UNITED STATES  
DEPARTMENT OF THE INTERIOR  
BUREAU OF LAND MANAGEMENTFORM APPROVED  
OMB NO. 1004-0135  
Expires: July 31, 2010**SUNDRY NOTICES AND REPORTS ON WELLS**  
*Do not use this form for proposals to drill or to re-enter an abandoned well. Use form 3160-3 (APD) for such proposals.***SUBMIT IN TRIPLICATE - Other instructions on reverse side.**

1. Type of Well <input checked="" type="checkbox"/> Oil Well <input type="checkbox"/> Gas Well <input type="checkbox"/> Other		8. Well Name and No. ELLIOTT EM 20 FEDERAL 4 ✓
2. Name of Operator APACHE CORPORATION ✓ Contact: REESA FISHER E-Mail: Reesa.Fisher@apachecorp.com		9. API Well No. 30-025-41444 ✓
3a. Address 303 VETERANS AIRPARK LANE SUITE 3000 MIDLAND, TX 79705	3b. Phone No. (include area code) Ph: 432-818-1062	10. Field and Pool, or Exploratory WANTZ; ABO
4. Location of Well (Footage, Sec., T., R., M., or Survey Description) Sec 20 T22S R37E SENW 2310FNL 2310FWL ✓		11. County or Parish, and State LEA COUNTY COUNTY, NM

**Elliot EM 20 Federal 4  
30-025-41444  
Apache Corporation  
Conditions of Approval**

## NOI TO TA ABO: ELLIOTT EM FEDERAL 20 #4 (30-025-41444)

- PROPOSED -

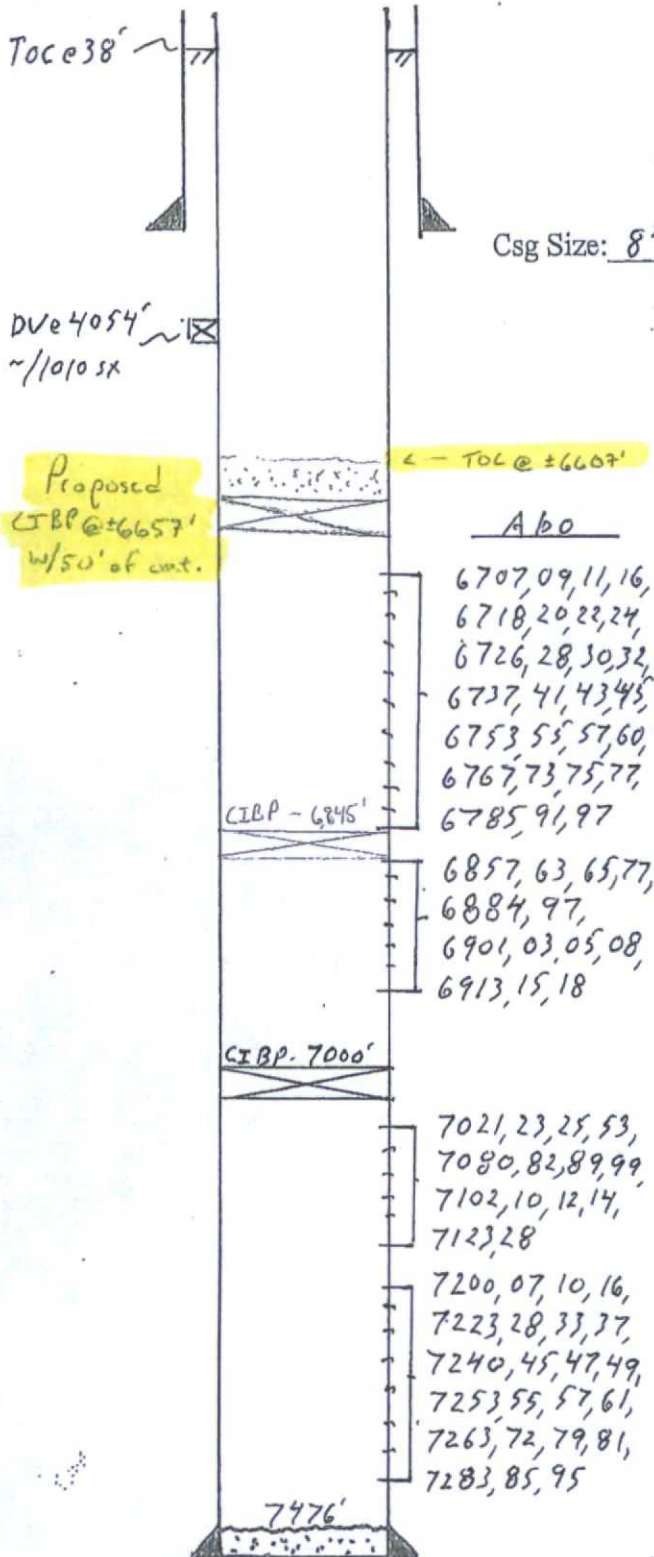
RIH with tubing, CIBP, and cement. Set CIBP @ ?6657?. PU and dump 50? of cement on top of CIBP. Contact the BLM field office at Carlsbad, NM to schedule a time to witness the tag on plug. Circulate wellbore to prevent corrosion while WOC. RIH and tag top of cement @ ?6607?. POOH and RDMO pulling unit.

1. Temporary Abandonment (TA) approved for 1-year from date of approval.
2. Operator approved to set a CIBP at 6657-feet and 50-feet of cement as a cap as proposed to abandoned the ABO. Tagged is required which shall be witnessed by BLM.

In the Sundry, the Plug Back action was checked not the Temporary Abandonment. Please confirm that it should actually be checked the Temporary Abandonment action, and I will correct this in the notification.

Day 1/2:      RIH with tubing, CIBP, and cement. Set CIBP @  $\pm 6657'$ . PU and dump 50' of cement on top of CIBP. Contact the BLM field office at ~~Carlsbad~~ Hobbs, NM to schedule a time to witness the tag on plug. Circulate wellbore to prevent corrosion while WOC. RIH and tag top of cement @  $\pm 6607'$ . POOH and RDMO pulling unit.
